**Brighton  
Council**

**ATTACHMENT A**  
**AGENDA ITEM 6.1**

St Ann's  
Lifestyle Village  
99-88, 28 Stanfield Drive,  
Old Beach Tas 7017

## REQUEST FOR FURTHTER INFORMATION RESPONSE

St Ann's	
Lifestyle Village	
99-88, 28 Stanfield Drive, Old Beach Tas 7017	
Project number	-
Date	20.09.2024
Drawn by	Author
Checked by	Checker
<b>A-101 Masterplan - Full Site</b>	
Scale @ A3	1 : 2000

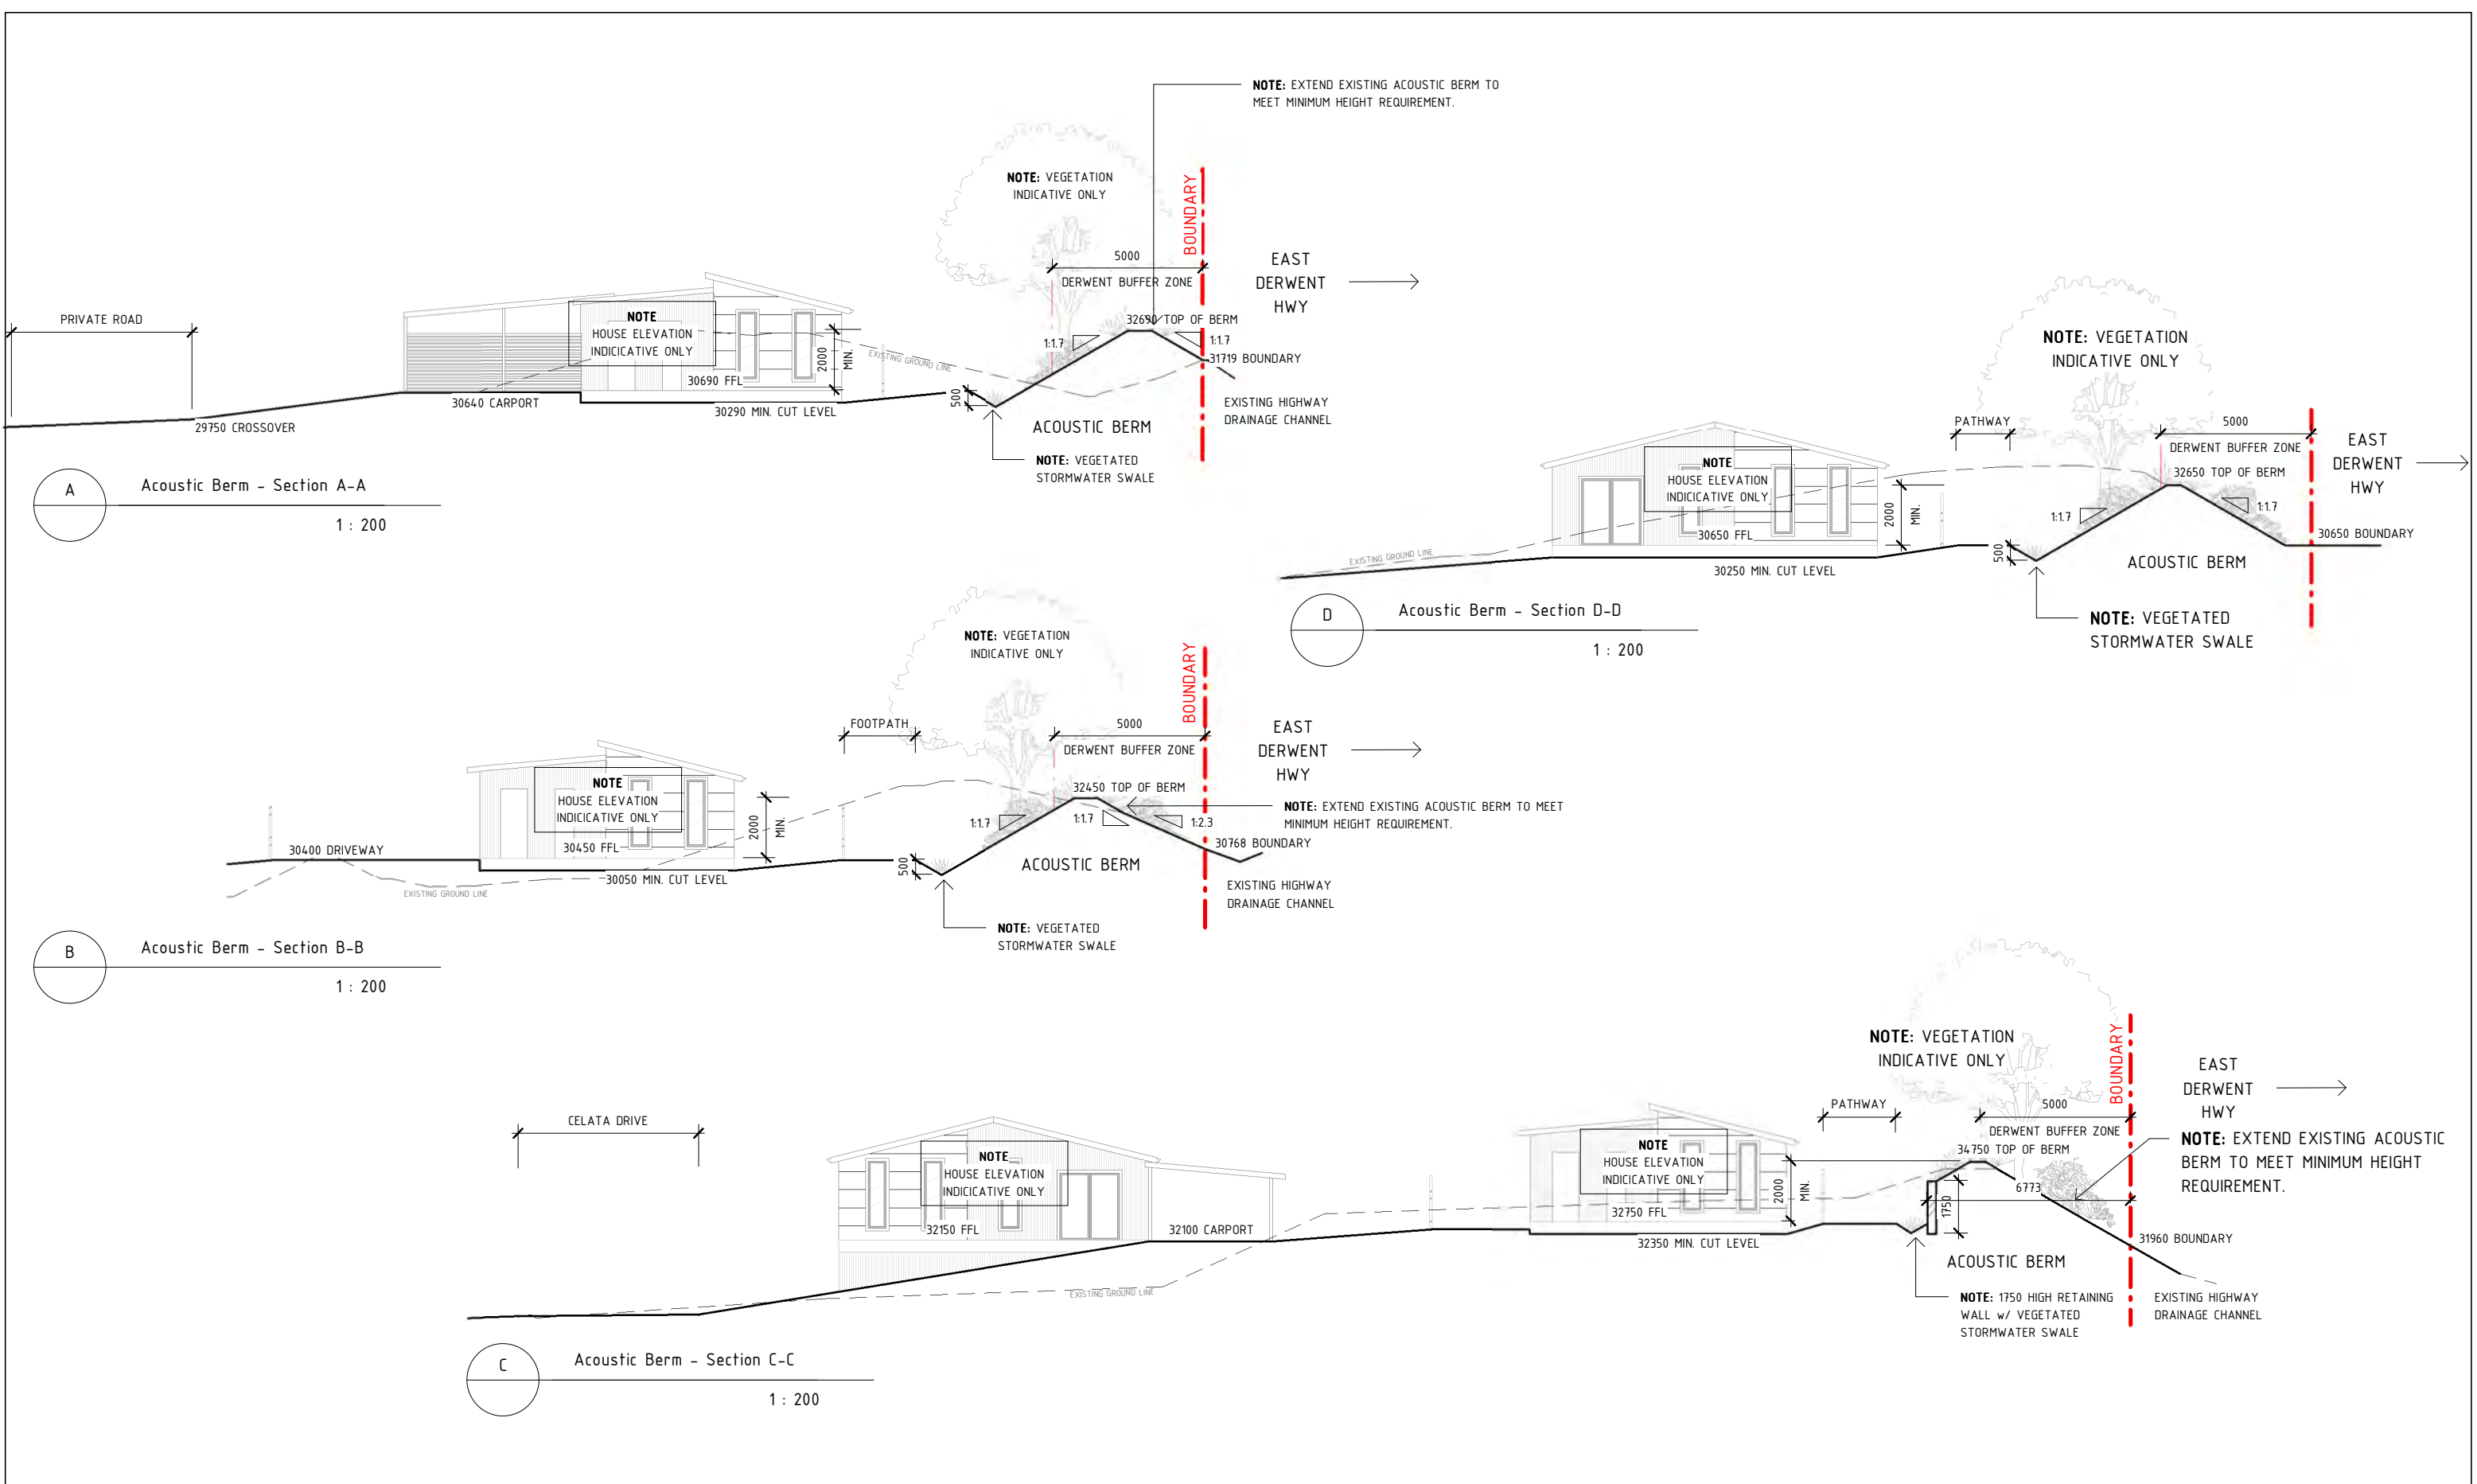
1. *Provide amended floor plans clearly indicating what unit type, etc, they relate to.*

The masterplan & lot plans have been amended to demonstrate the correct house typology and number.

# APPENDIX 1      SWEPT PATH DIAGRAMS

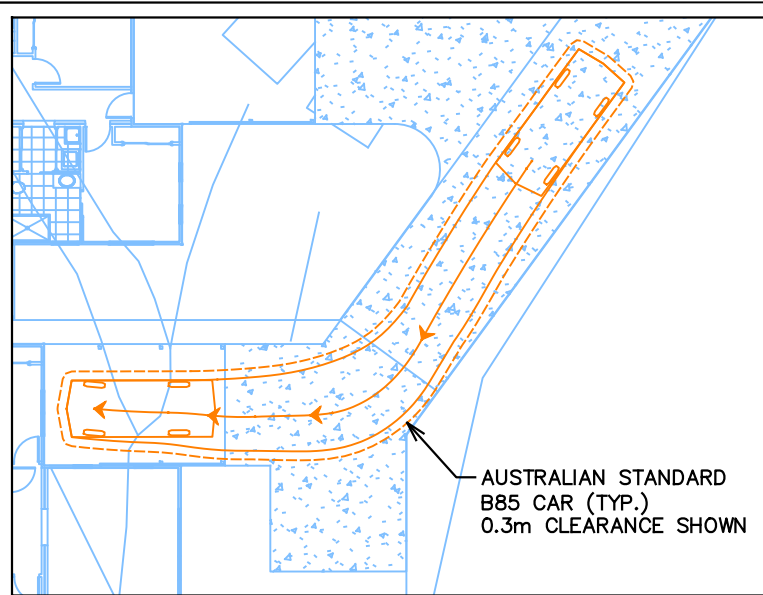
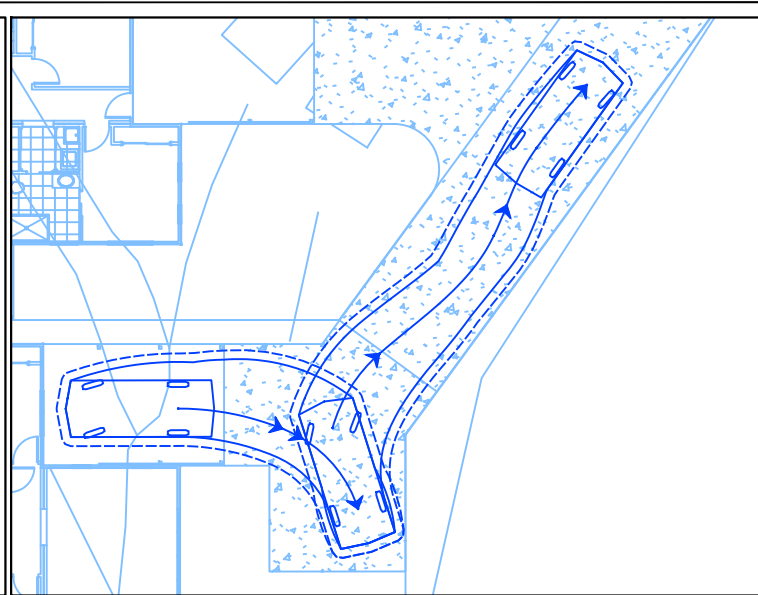
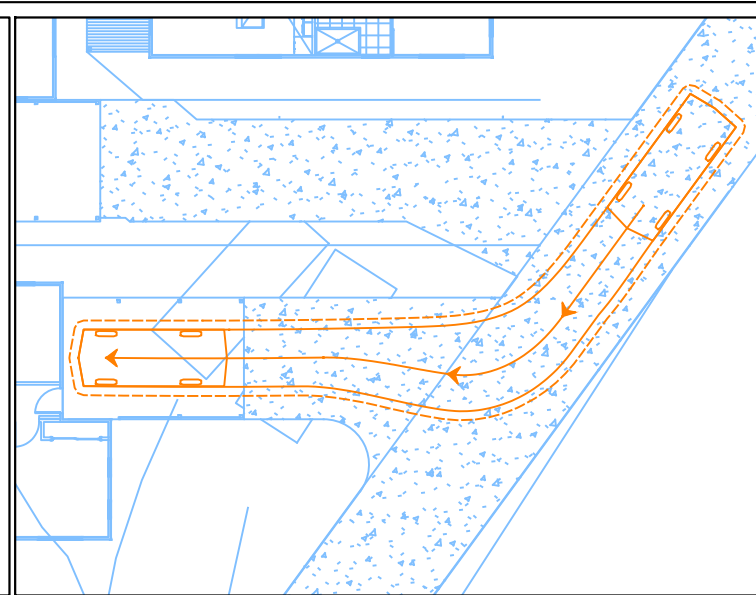
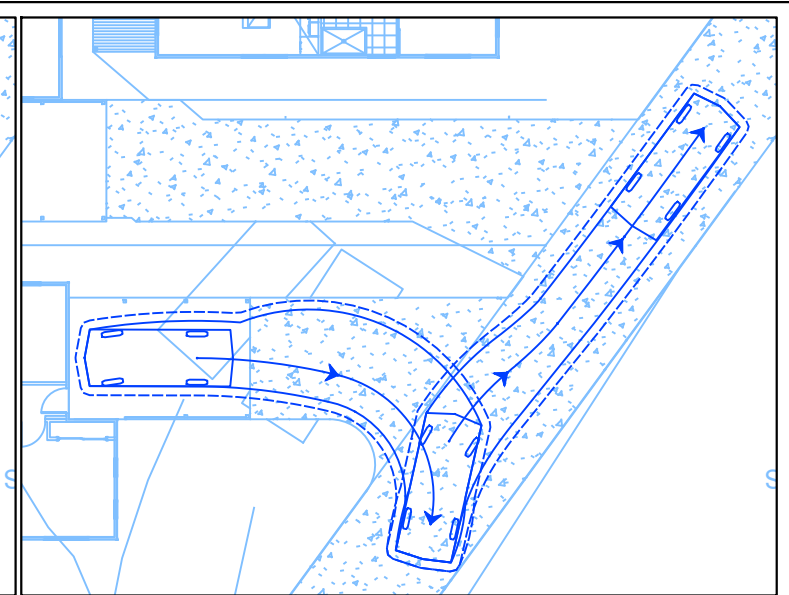
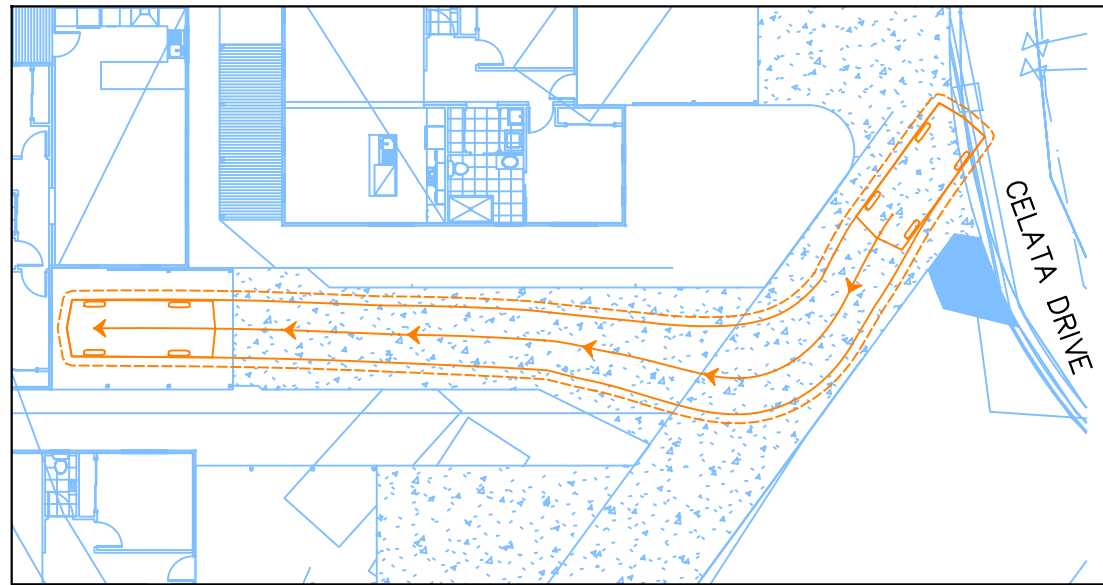
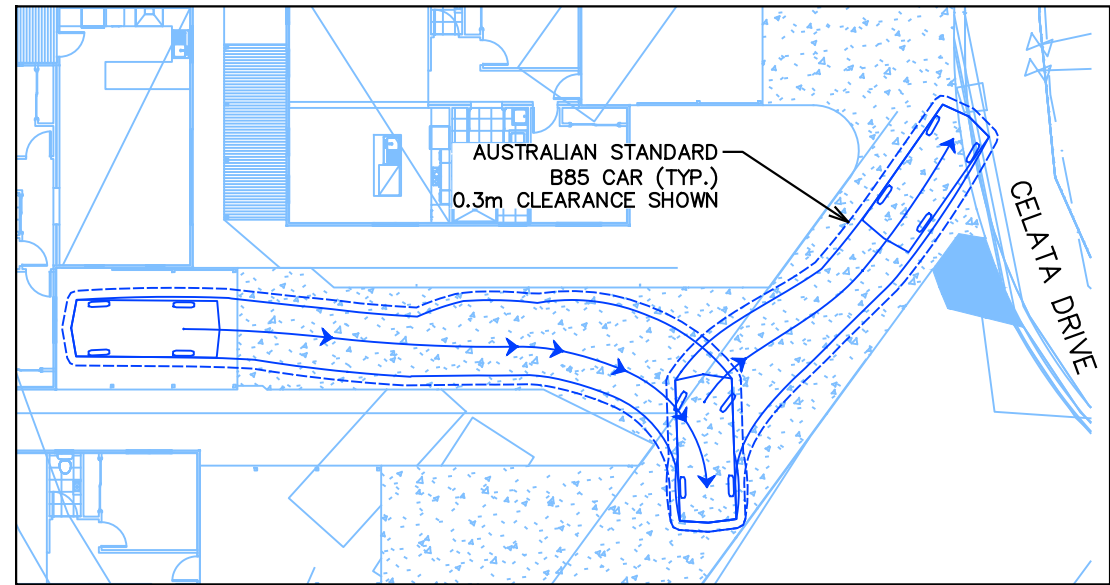
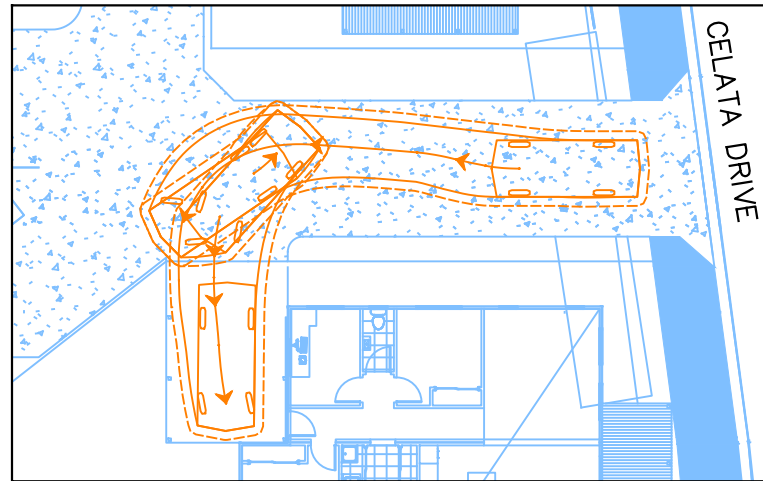
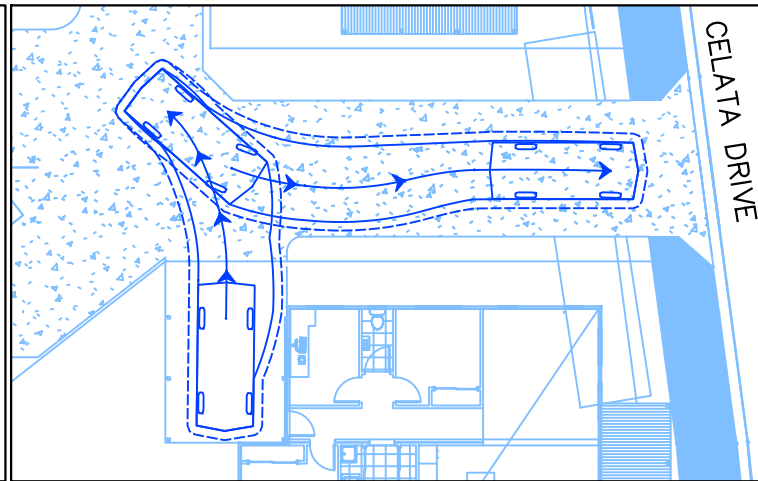
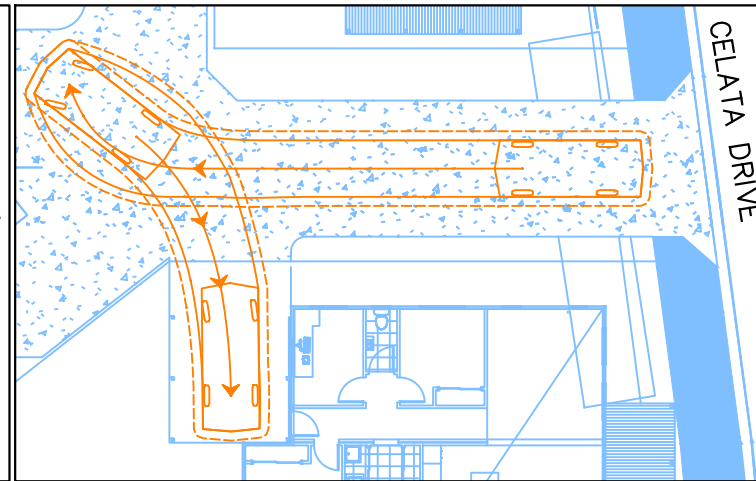
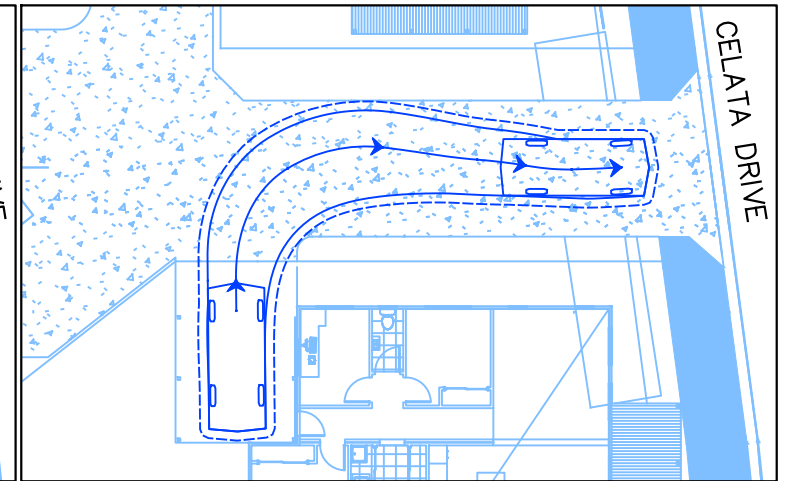
Nevertheless, the driveway has been modified to allow vehicles to access these carports without the need to perform three-point turns. SALT has prepared updated swept path diagrams, attached as **APPENDIX 1** at the end of this letter, that demonstrate:

The site layout plans have been amended and now show that the maximum difference between the carport and dwelling floor levels will be 50mm, which obviates the need to provide stairs into the dwellings.
